SUBJECT: NRC SITE VISIT TO THE OCONEE NUCLEAR STATION ON  
JUNE 15, 2009

## SUMMARY OF NRC SITE VISIT TO THE OCONEE NUCLEAR STATION JUNE 15, 2009

**Saddle dikes at Jocassee Lake are protected from wave action by rip rap on sides facing lake. Top: Saddle Dike #2. Middle: rip rap on lake side of Dike #1. Right: downstream side of Dike #1 has grass but no rip rap (french drain is visible along toe of dam).**

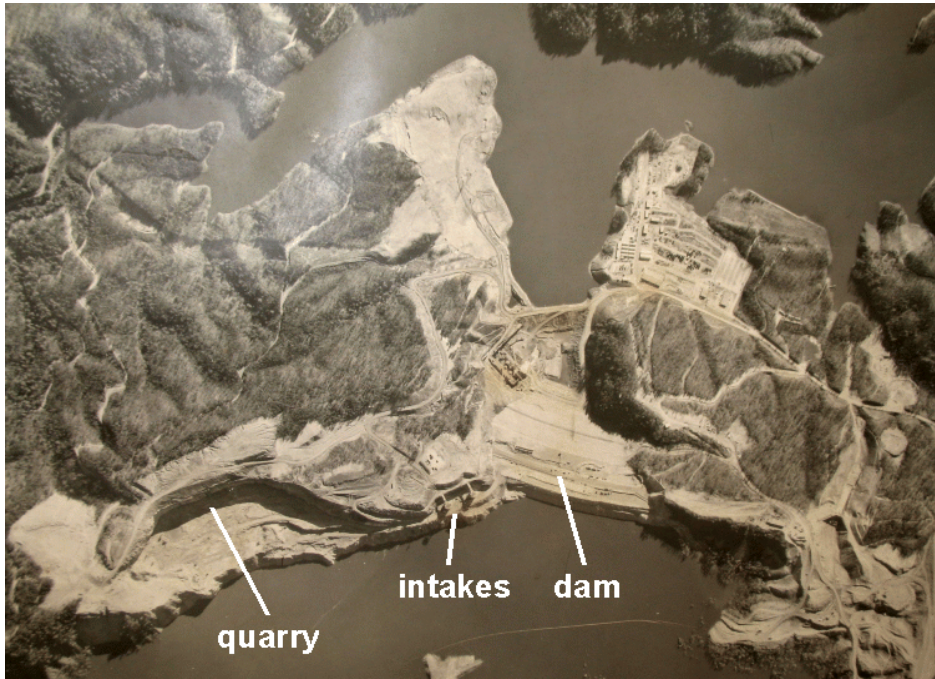
There are two earthen saddle dikes west of the main Jocassee dam, which could potentially function as an uncontrolled spillway in the event of a severe storm coupled with an inoperable spillway gate. The crest elevations of these dikes are the same as that of the main dam. These two saddle dikes could provide emergency outlets that could prevent overtopping failure of the Jocassee dam. Overtopping failures are the most hazardous for any dam. As shown in the photos below, Saddle Dikes #1 and #2 do not have rip rap on their downstream sides. If overtopped, they would rapidly erode forming breaches that would drain the reservoir down to the base level of the dikes. This would still allow the reservoir to retain most of its water volume, averting a catastrophic emptying of the entire lake. Both dikes are protected from wave erosion by rip rap armoring on the lake-facing slopes. Lowering the saddle dikes by ~0.5 m would provide further assurance that if a probable maximum flood inflow occurred to Jocassee Lake, failure of the saddle dikes would prevent overtopping and catastrophic failure of Jocassee Dam.

The main Jocassee dam was observed to be in good condition without any obvious signs of instability. The hydrogeologist identified the rock type as biotite gneiss (see figure below) used for rip rap and reportedly used as rockfill material in the Jocassee dam. This rock type is not the kind that would degrade over time. The staff found no evidence of degradation of the rockfill material within the dam because the seepage observed was clear with no obvious suspended solids.
